SUBJECT: ST. LUCIE UNIT 1 - ISSUANCE OF AMENDMENT RE: BORIC ACID MAKEUP TANK
MINIMUM INVENTORY REQUIREMENTS (TAC NO. M88976)

Amendment No. 129
License No. DPR-67

ATTACHMENT TO LICENSE AMENDMENT NO. 129

SAFETY EVALUATION BY THE OFFICE OF NUCLEAR REACTOR REGULATION

**FIGURE 3.1-1 ST. LUCIE 1 MIN BAMT VOLUME
VS STORED BAMT CONCENTRATION**

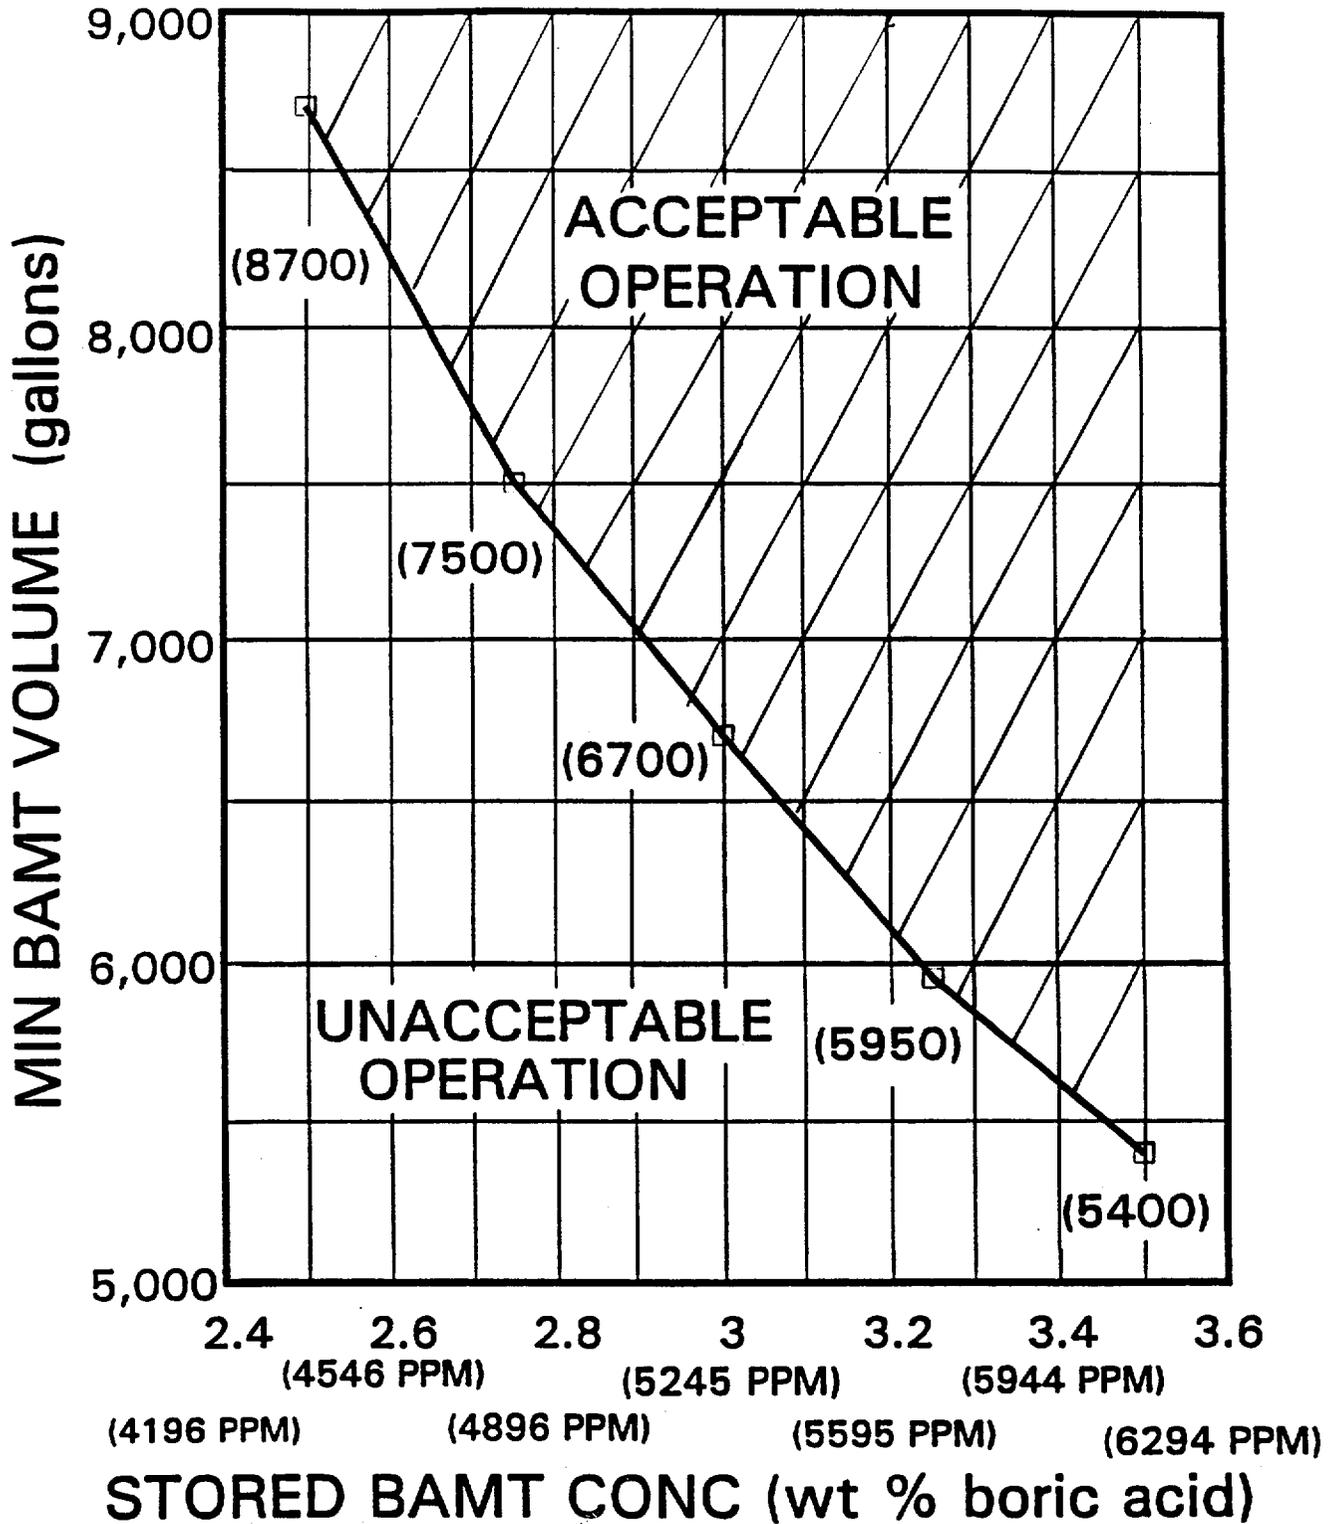
This amendment modifies the minimum stored borated water inventory requirements for Operational Modes 1 through 4 by revising Figure 3.1-1 and Limiting Condition for Operation 3.1.2.8 of the unit Technical Specifications (TS). The associated bases for TS 3/4.1.2 are also revised to reflect the bounding borated water makeup volumes, as a function of boric acid concentration, which define the proposed inventory requirements.

By letter dated February 22, 1994, Florida Power and Light (FPL) (the licensee) proposed changes to the Technical Specifications (TS) for the St. Lucie Unit 1 facility. Specifically, the proposed changes were a modification of (1) Figure 3.1-1, (2) the Limiting Condition for Operation (LCO) 3.1.2.8 and (3) the associated bases for TS 3/4.1.2. These changes are related to reducing the minimum stored borated water inventory requirements. It is the licensee's contention that the proposed amendment will significantly improve operational flexibility with no risk to plant safety and that it will also provide consistency in operation between the Unit 1 and Unit 2 plants.

Available Borated Water Inventory (Figure 3.1-1)

The licensee stated that the proposed BAMT inventory reduction is made possible by increasing the make-up water provided by the RWT during plant cooldown. The boration requirements were determined by the licensee using conservative assumptions in order to maximize the boron demand. It was also assumed that the approved boric acid concentration of 2.5 - 3.5 percent by weight (wt%) in the BAMT remained the same. The licensee concluded that additional demand on the RWT inventory has no impact on the existing TS RWT minimum volumes and boron concentration.

In the currently documented volume reduction analysis, CEN-353(F), Revision 3, 1000 gallons of borated water was added to the calculated BAMT volume to provide additional volume for auxiliary spray while depressurizing the RCS. The additional volume is required because the analysis assumes that motor-operated valve V2504 fails to automatically open. In Supplement 1 to CEN-353(F), Revision 3, the volume reduction analysis for these proposed changes, the final volume is determined by (1) adding a 500-gallon allowance for conservatism and (2) removing the additional 1000-gallon allowance for auxiliary spray from the BAMTs. The licensee justifies this reduction by taking credit for manual handwheel operation of V2504. These BAMT volume adjustments are consistent with the volume adjustments made for St. Lucie, Unit 2.

In the case where one BAMT is used, the maximum useable capacity is 9450 gallons and TSs 3.1.2.8.a and b currently specify a minimum boric acid concentration of 3.2 wt% for an individual BAMT. Figure 3.1-1 is actually based on the use of two BAMTs. This results in limiting the range of permissible inventories for the selected tank to the narrow operating band delineated in Figure 3.1-1 of the current TSs.

By reducing the inventory to the single BAMT range of 5,400 - 8,700 gallons, the corresponding boric acid concentration is 3.5 - 2.5 wt%, respectively. Therefore the 3.2 wt% minimum for the boric acid concentration for an individual BAMT is not required.

The licensee has proposed to modify Figure 3.1-1 and TS 3.1.2.8 so that the requirements will be applicable to an individual BAMT. These changes are supported by the analytical results of CEN-353(F) Supplement 1 which includes previously approved methodologies, worst-case assumptions, and allowances for the uncertainties.
